### **REMARKS/ARGUMENTS**

Appl. No. 09/845,473  
Amdt. dated September 7, 2004  
Response to Office action of June 15, 2004

Attached are amended sheets of drawings for Figures 3, 5, 7, 8, 10, and 16-18. The amendments to the Figures are shown in red. In Figure 3, the lead line to the annulus 83 has been corrected. Reference numeral 162 in Figure 5 has been changed to 162a,b. Reference numerals 102a,b have been added to Figure 7 and Reference numerals 122a,b have been added in Figure 8. Likewise reference numerals 168 and 166a have been added to Figure 10. Further reference numerals have been added to Figures 16-18 at the request of the Examiner. Applicant requests that these drawing amendments be approved.

*Fig. 7*

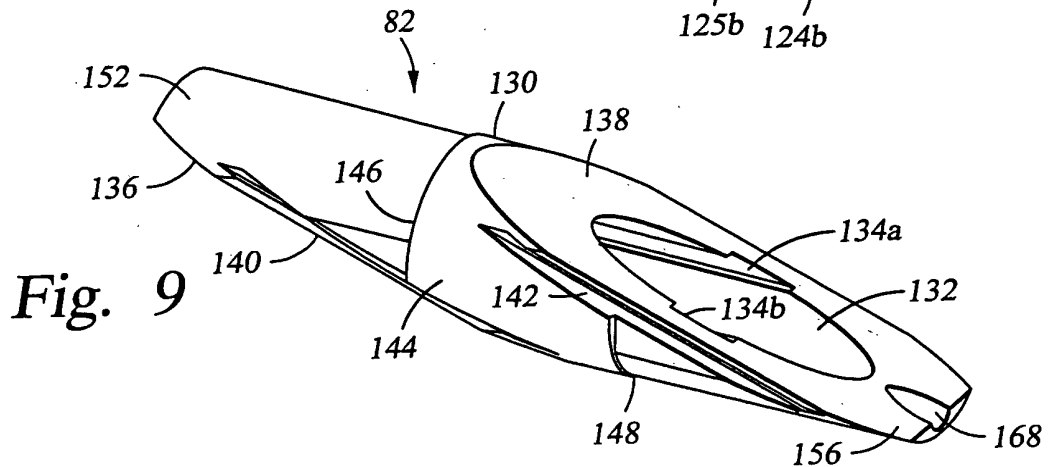
The examiner objected to the drawings as failing to comply with 37 CFR 1.84(p)(5) stating that they do not include the following reference signs mentioned in the description: 102a, 102b, 122a, 122b, 140a, 140b, 142a, 142b, 162a, 162b, 158a, 158b, 166, 124, 118, 158, and 402.

numerals 102a,b have been added to Figure 7 and Reference numerals 122a,b have been added in Figure 8. Likewise reference numerals 168 and 166a have been added to Figure 10. The specification has been amended to refer to reference numeral 140 and 142 instead of 140a,b and 142a,b so that the specification conforms to the drawings. Likewise the specification has been amended to reference numerals 124a,b, 118a,b, 158a,b, and 166a,b. Applicant respectfully submits that the drawings are now in proper form.

Fig. 17

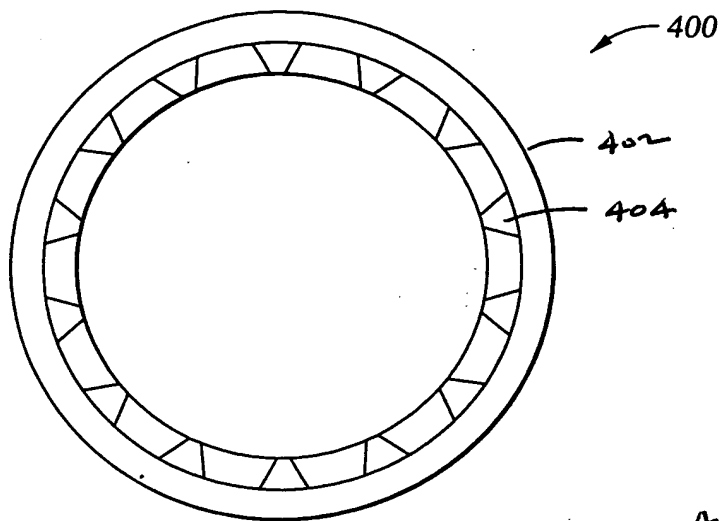
The examiner objected to the drawings stating that Figures 16-18 do not contain any reference numbers that the examiner considers necessary for a complete understanding of the claimed invention. Applicant has added reference numerals 403 and 404 to Figure 16 and has added reference numerals to Figures 17 and 18 based on the disclosure from pages 11-16 of U.S. Provisional application No. 60/201,193, filed May 2, 2000 and entitled Traction Module incorporated by reference in paragraph [057] in the present application. New paragraphs [057.1]-[057.10] from pages 11-16 of U.S. Provisional application No. 60/201,193, filed May 2, 2000 and entitled Traction Module incorporated by reference in paragraph [057] in the present application have also been added for the description of the newly added reference numerals. No new matter has been added. In view of these amendments, Applicant respectfully submits that Figures 16-18 are now in proper form.
